MSO/MST Firmware 2.07.x bug list:

List of bugs/improvement requests

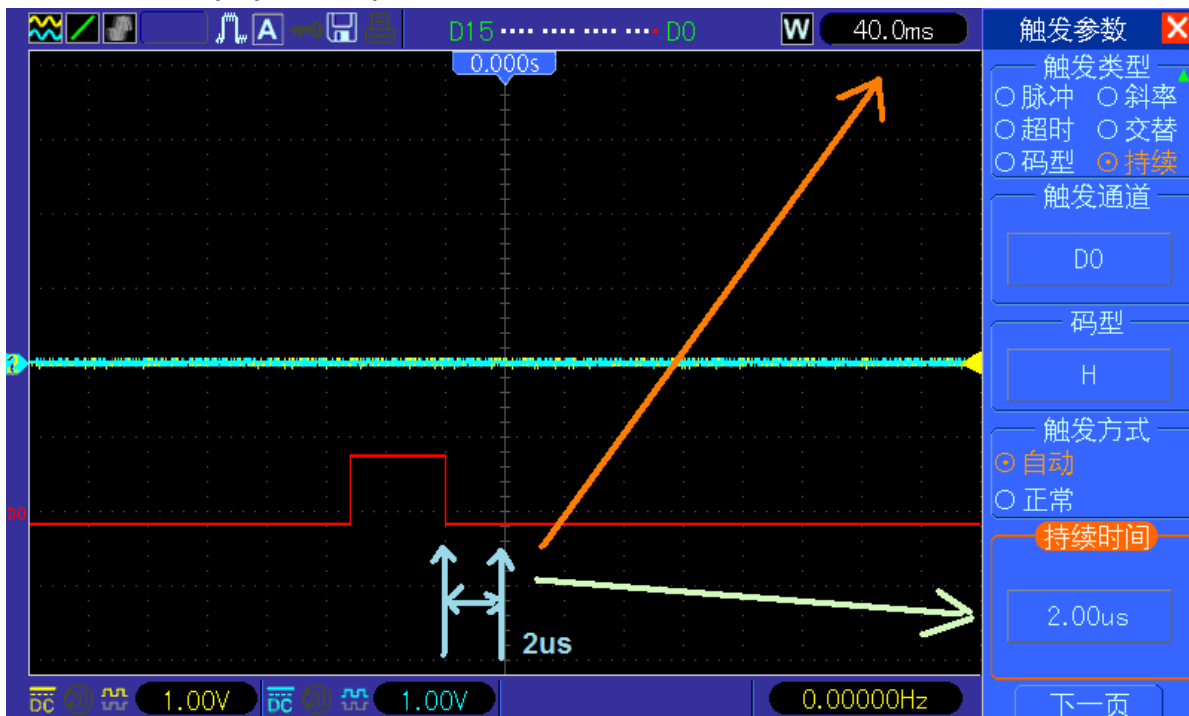
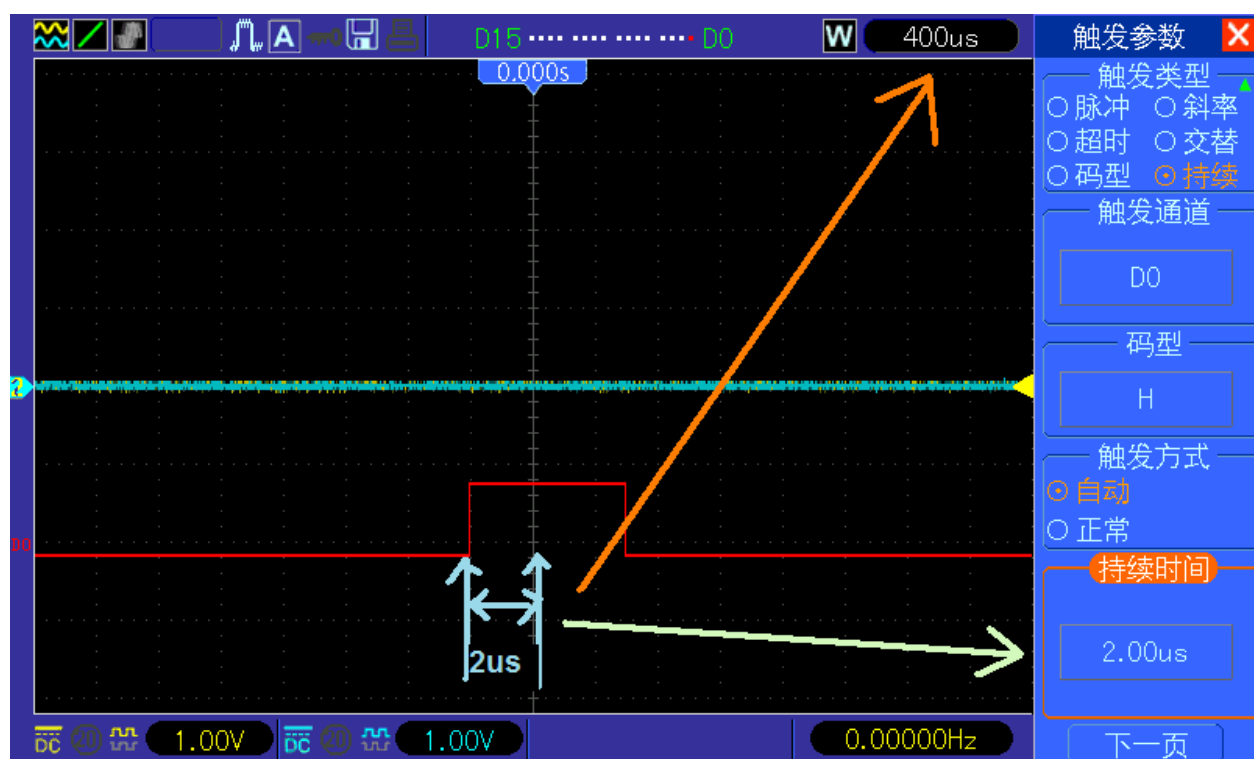
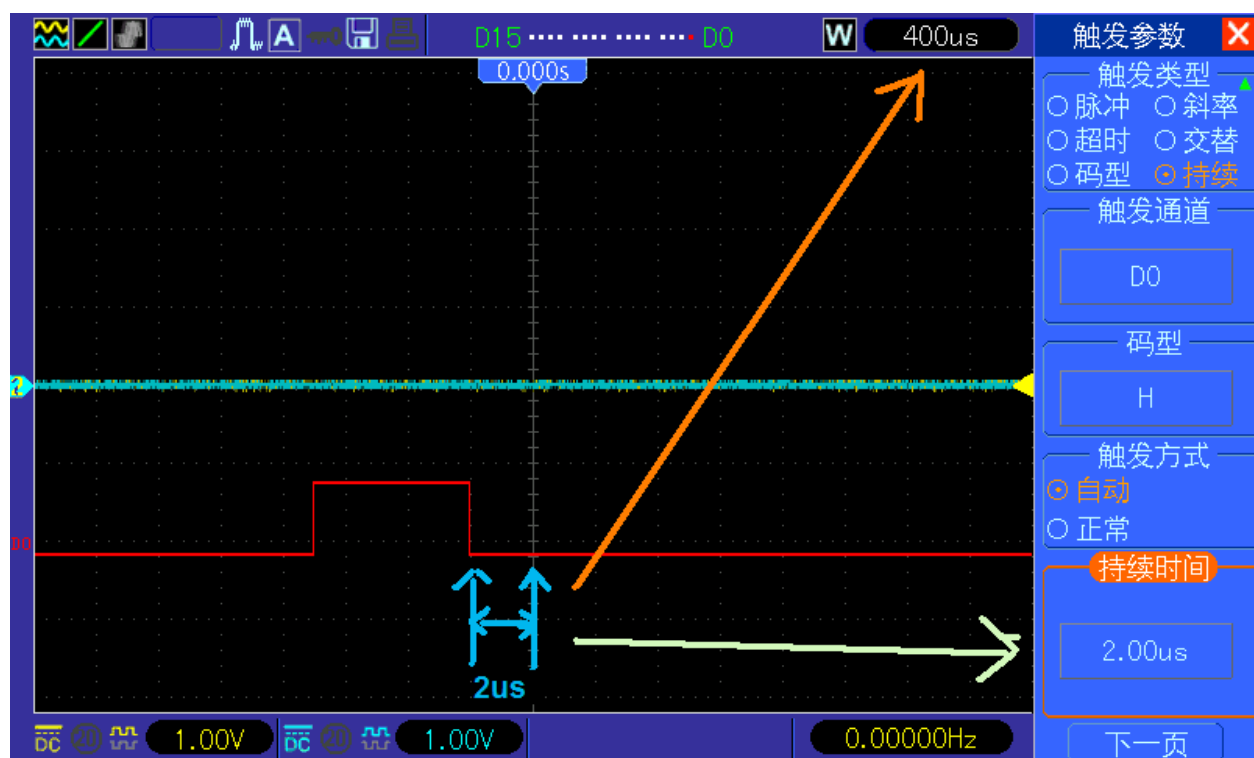
46. There seems to be skew between LA and analog channels, LA is delayed about 50ns. This is especially visible on timebases between 200ns/DIV and 2ns/DIV.

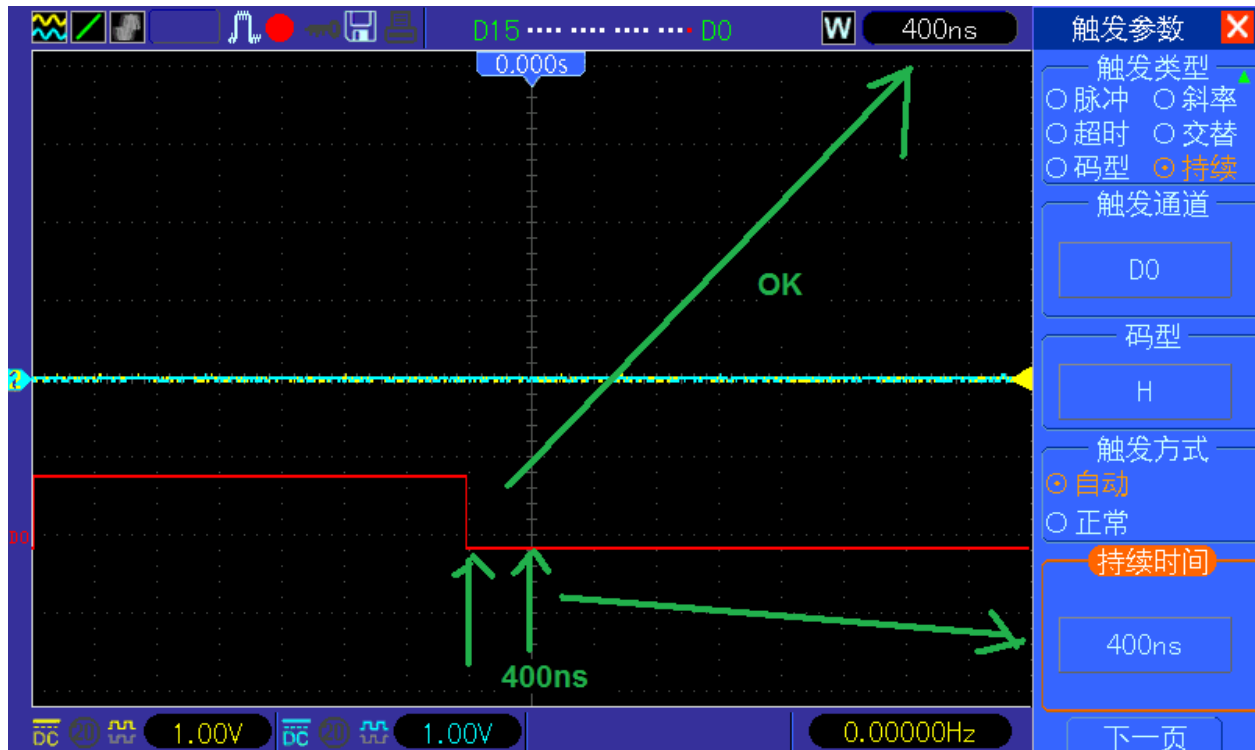
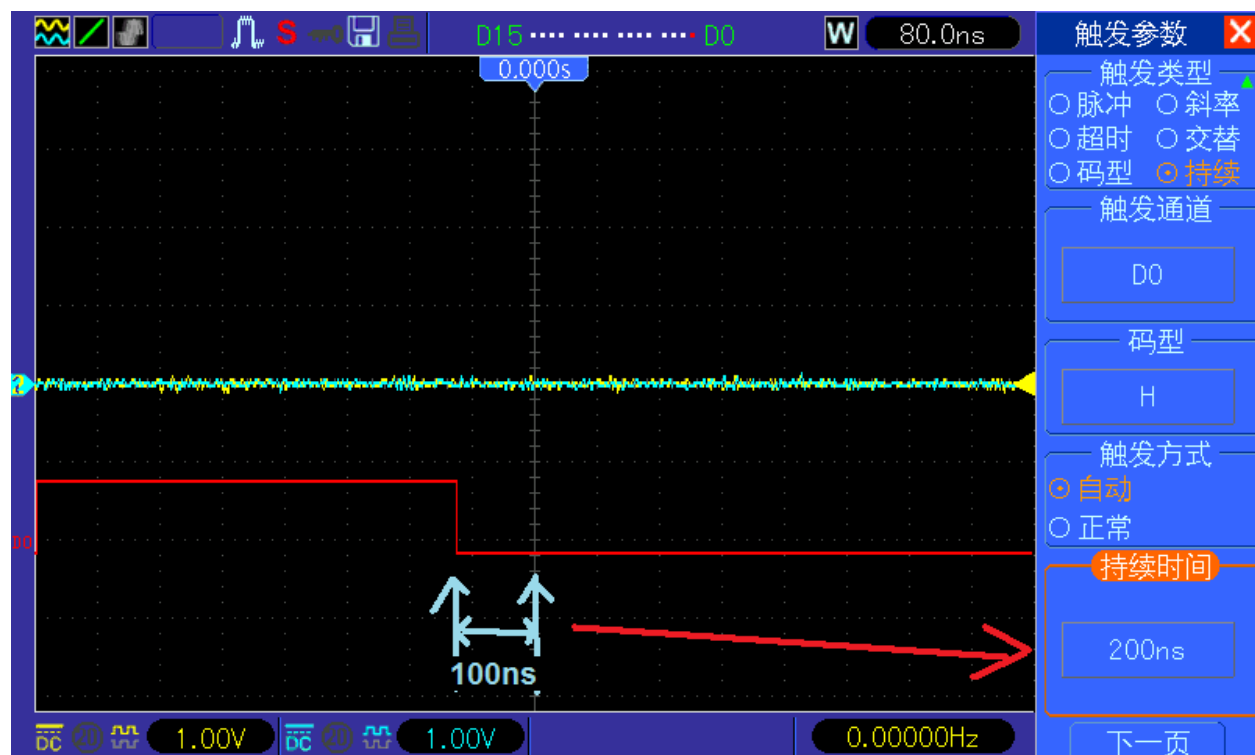
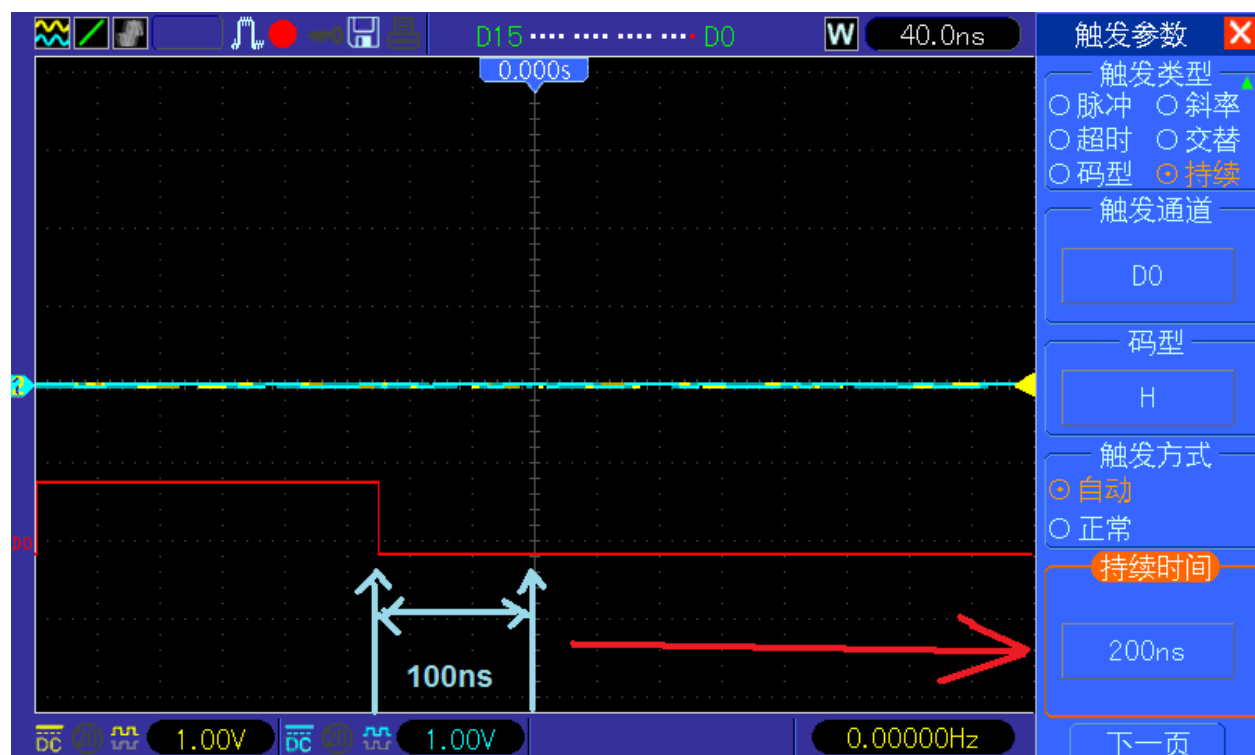
47. When LA enabled, the firmware is always enabling both channels, is this deliberately so?
48. LA - Duration trigger / "Begin of data" and "End of Data" (NOTE: the bug 36 "H and L letters swapped" need to be fixed first to properly see the duration trigger bug).
when timebase set from 40ms to 4us the duration scale is fixed to 2us/DIV. No matter what set as duration, one display DIV is equal 2us:

when timebase from 2us to 200ns - everything ok

when timebase from 80ns to 2ns the duration scale is again wrong, like fixed always to 100ns no matter what set as duration:

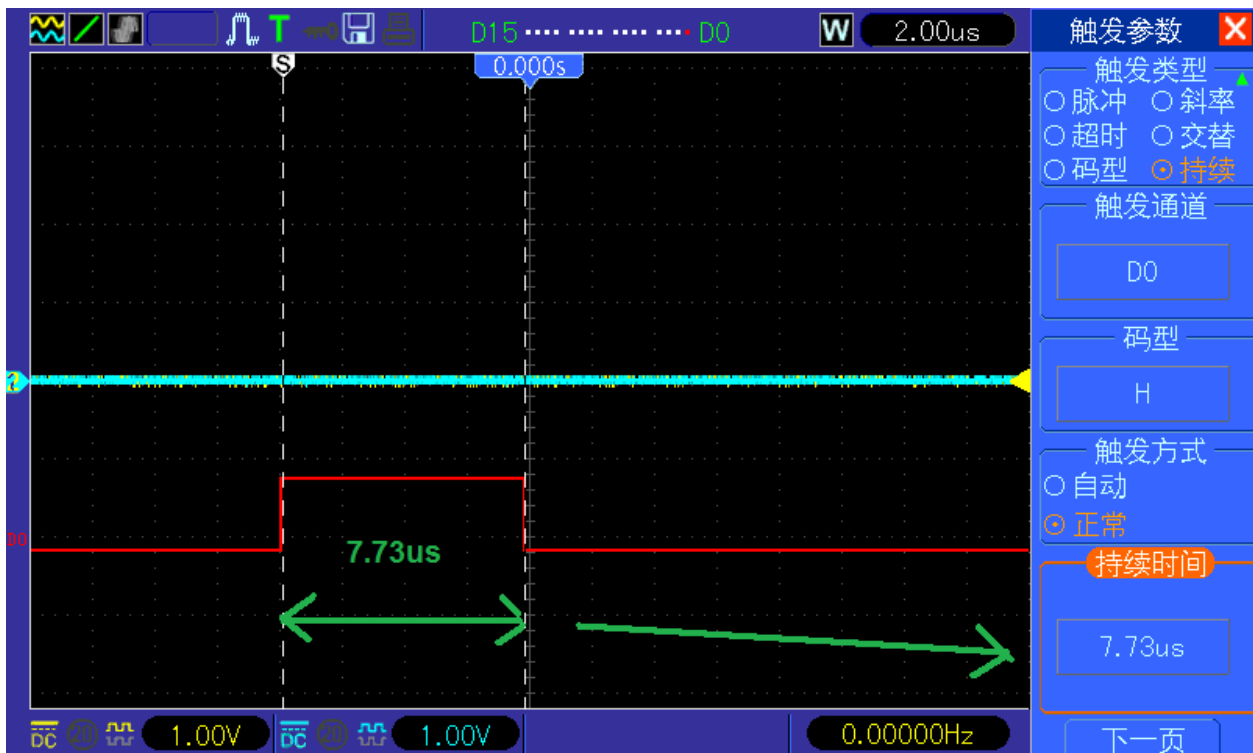
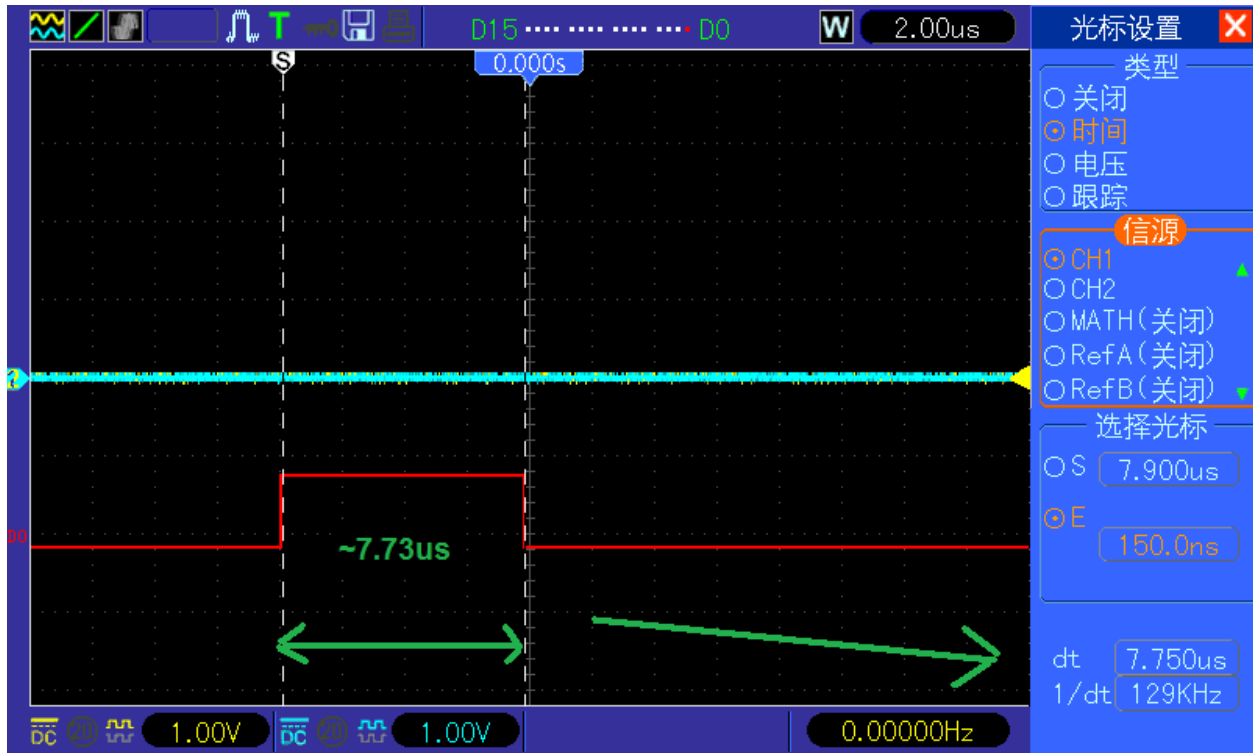
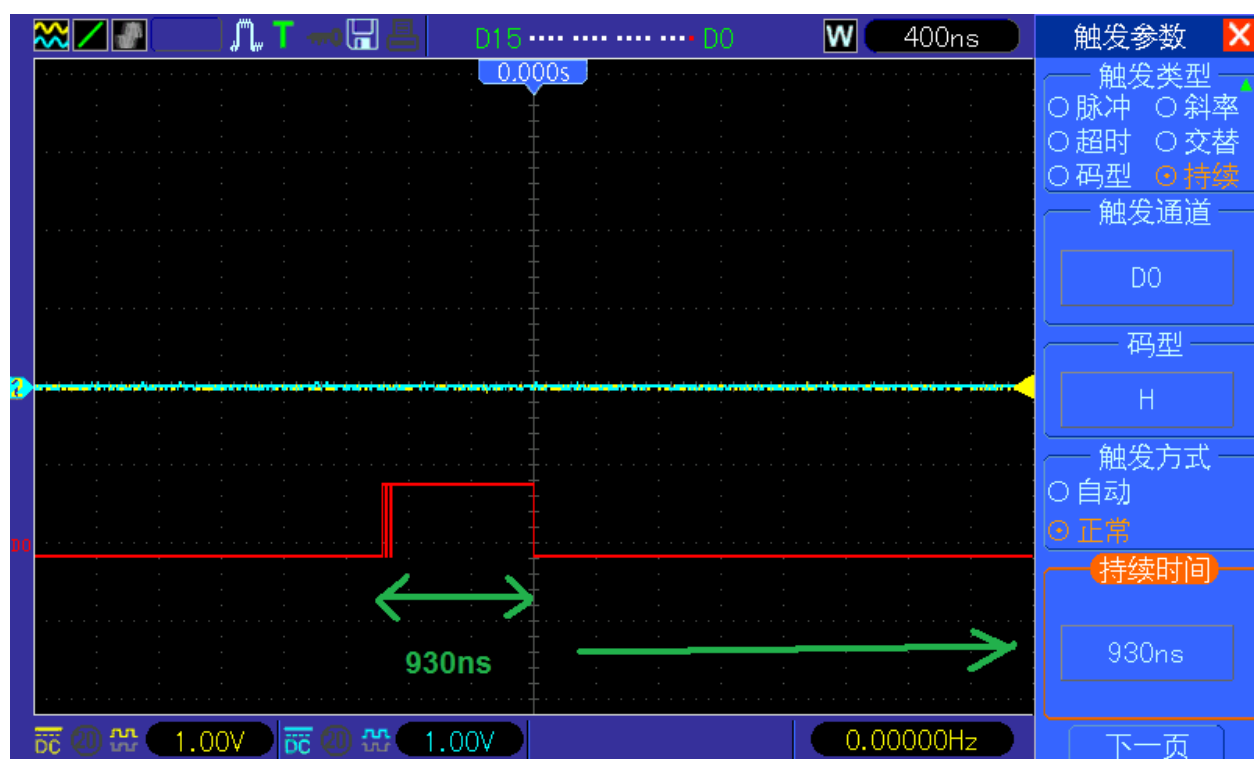
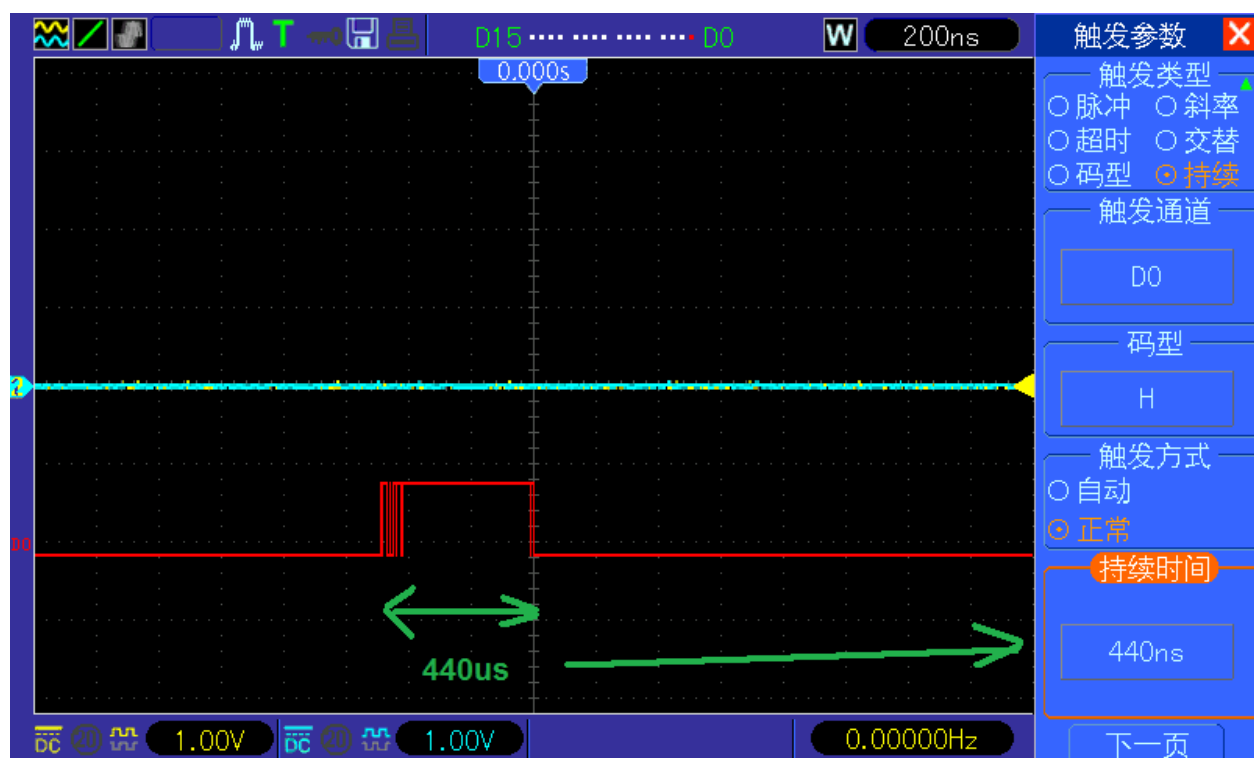
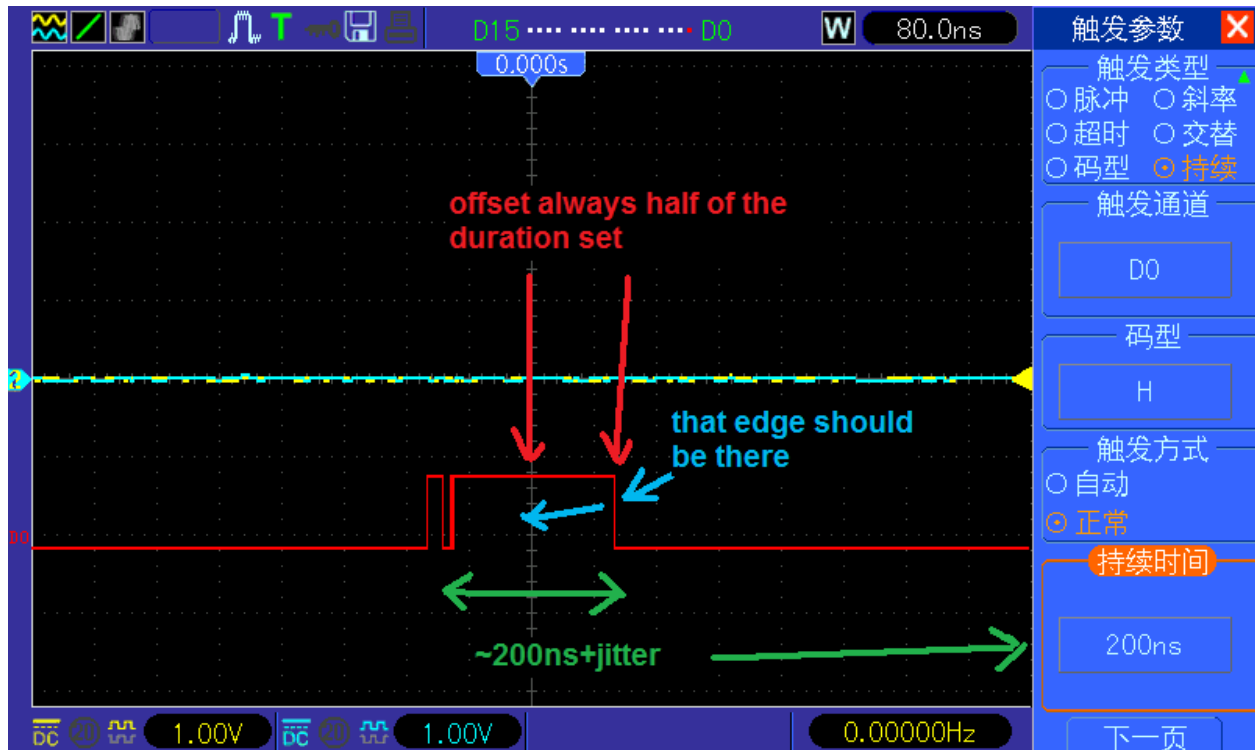
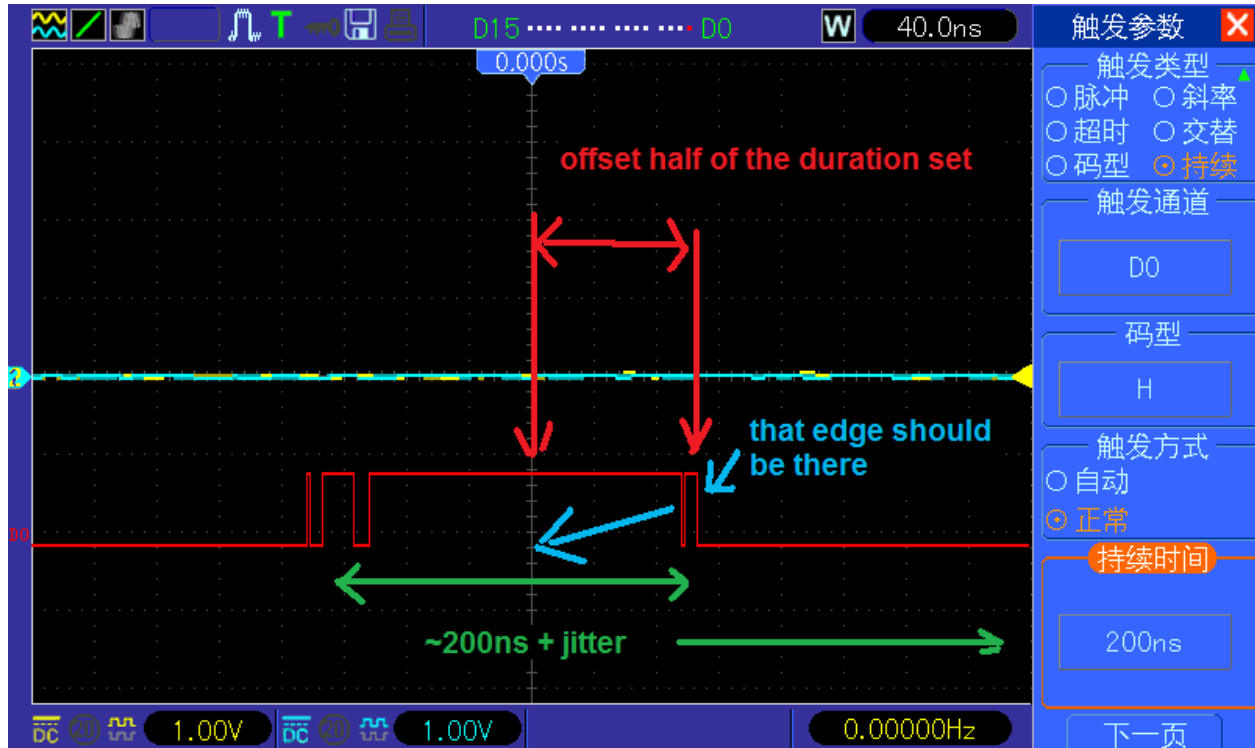
49. LA - Duration trigger / "Data delay" (NOTE: the bug 36 "H and L letters swapped" need to be fixed first to properly see the duration trigger bug).

Works properly only when timebase set from 2us/DIV to 200ns/DIV:

From 80ns/DIV to 2ns/DIV partially ok, the data delay length will be properly triggered (except jitter, but that's ok), however the position have some offset (always about half of the duration set):
